Summary and Analysis of Comments to the
Notice of Proposed Rulemaking:

"Evaporative Emission Regulation and Test Procedure
for Gasoline-Fueled Heavy-Duty Vehicles"

April 30, 1980

Standards Development and Support Branch
Emission Control Technology Division
Office of Mobile Sources
Office of Air, Noise and Radiation
U.S. Environmental Protection Agency

Figure 1 Composite Distribution of Differential
Daily Temperatures - 5 Cities
(July & August)

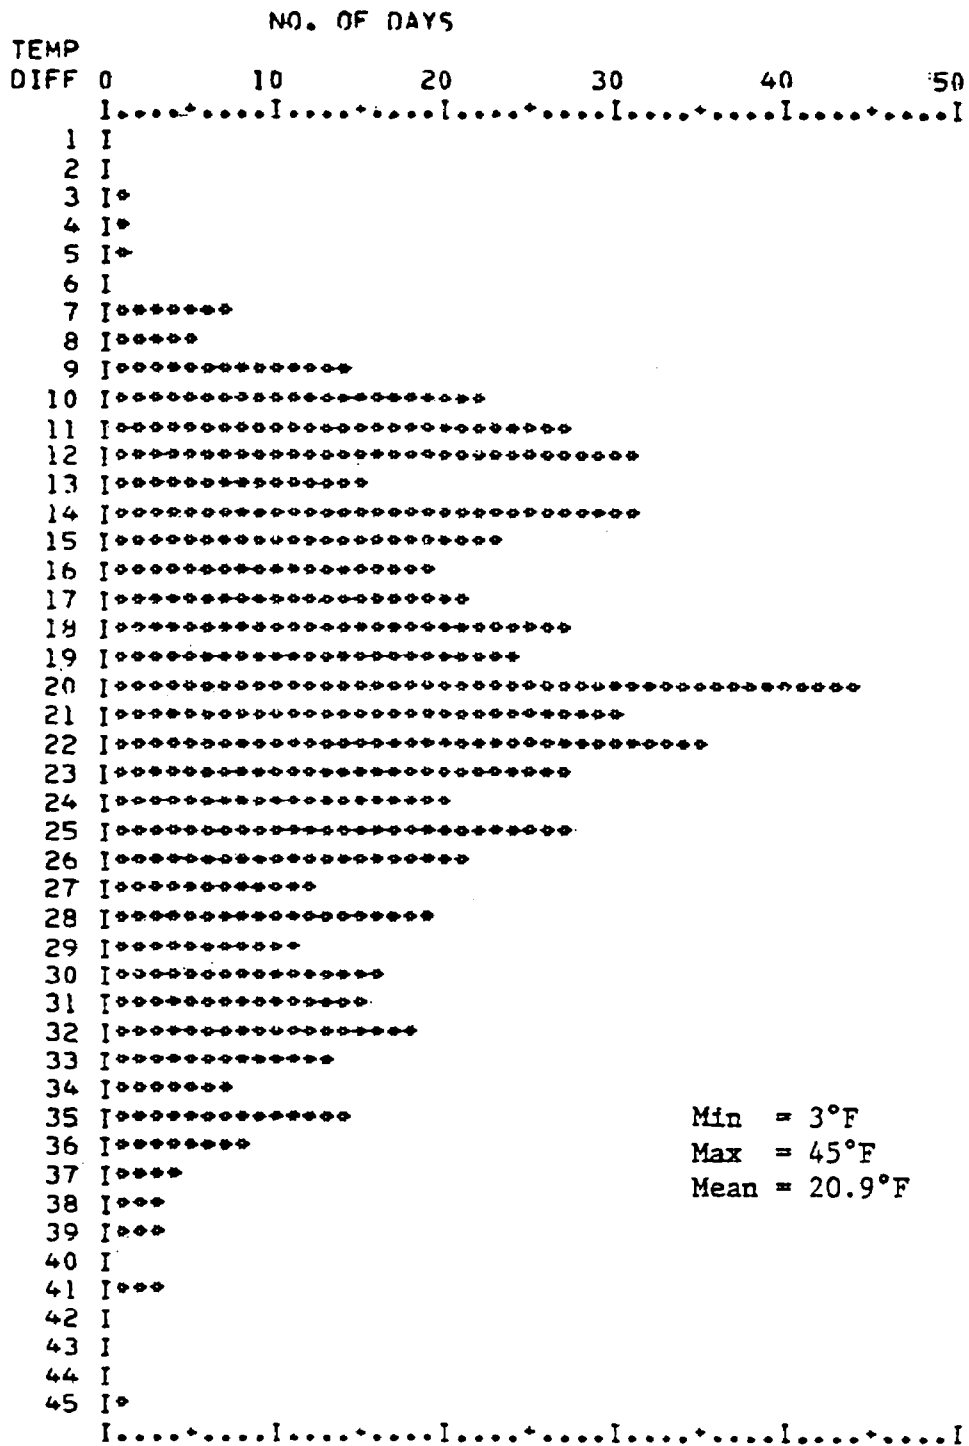
The typical summertime ambient temperature diurnal to which GM referred is exceeded many times. In fact, a 32°F ambient diurnal is not at all uncommon as Figure 1 indicates. A test procedure fuel temperature rise of 75 percent of such a 32°F ambient diurnal would yield 24°F. This is the fuel temperature rise of the proposed test procedure and we recommend its retention in the Final Rule.
